TRUS-T-LIFT™ 750

Back Up Safety Nut Indicator Bracket

PRODUCT BULLETIN

Figure 1: Trus-T-Lift™ Guide Frame Assembly

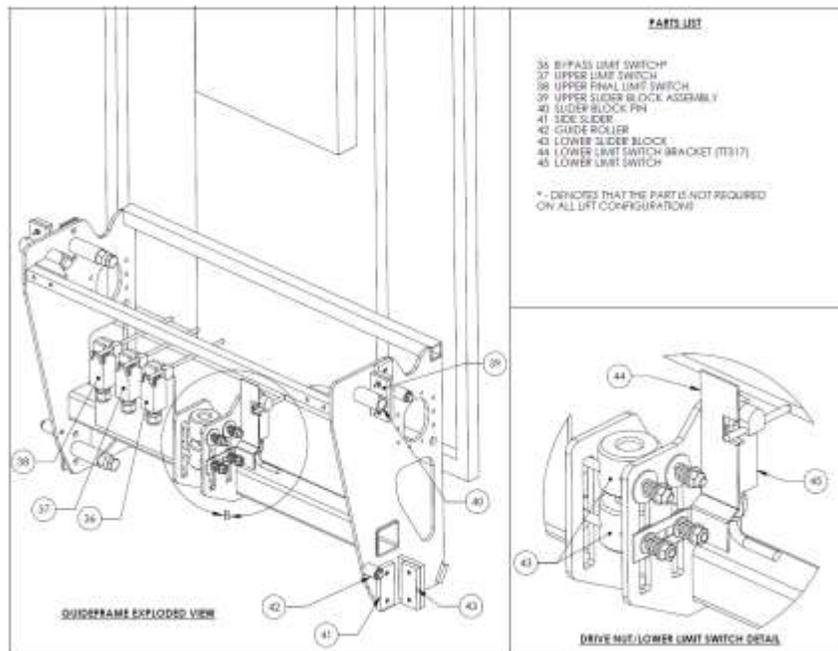
The following image, figure 1, shows the old revision of bracket (item 44). If the lower limit switch rod is not captured in the slot as shown in the lower limit switch detail please replace it in the slot immediately and then proceed to procure and replace with a revised bracket. An image of the revised bracket is shown in figure 2 below.

1. Inspect their affected lift(s) to make sure the lower limit switch rod is captured properly.
2. Replace any older revision bracket with a new one during the required annual maintenance or when they observe that the rod is out of place.

Figure 2: Old Revision Bracket on Left, Revised Bracket on Right

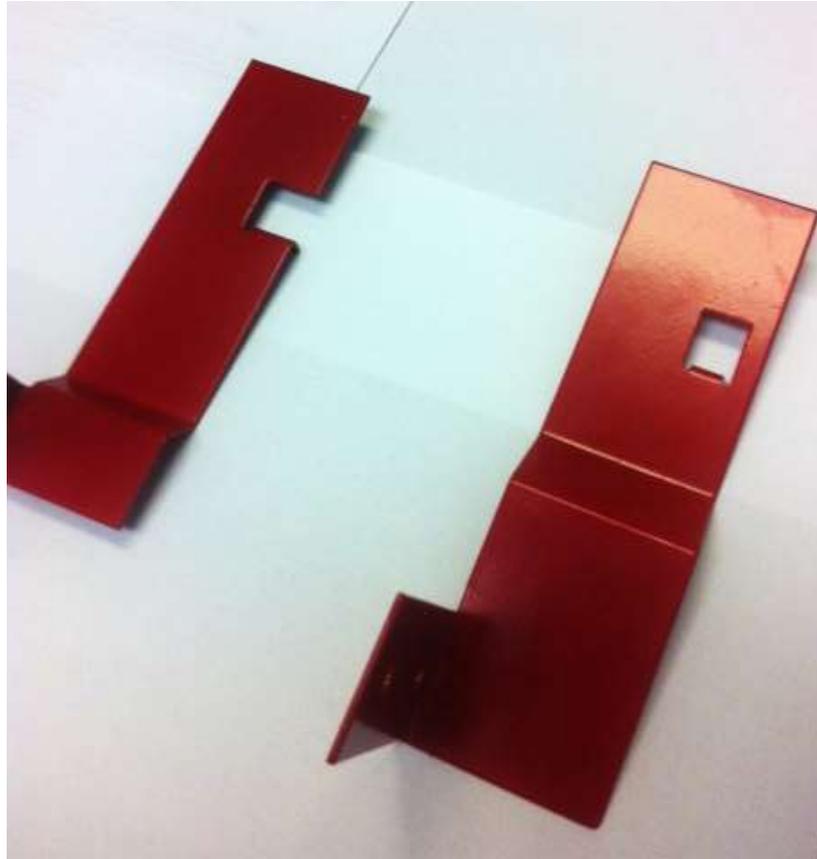
After some field reports that the lower limit switch rod had the possibility of not being engaged properly in the bracket. RAM has made a revision to the bracket to improve the capture method and ensure that the bracket face is closer to the limit switch.

RAM will provide a newly revised back up safety nut bracket free of charge to anyone who needs to replace the older version on a Trus-T-Lift™ 750. Please contact RAM technical support at 1-800-563-4382 to arrange for a new bracket should you need one.
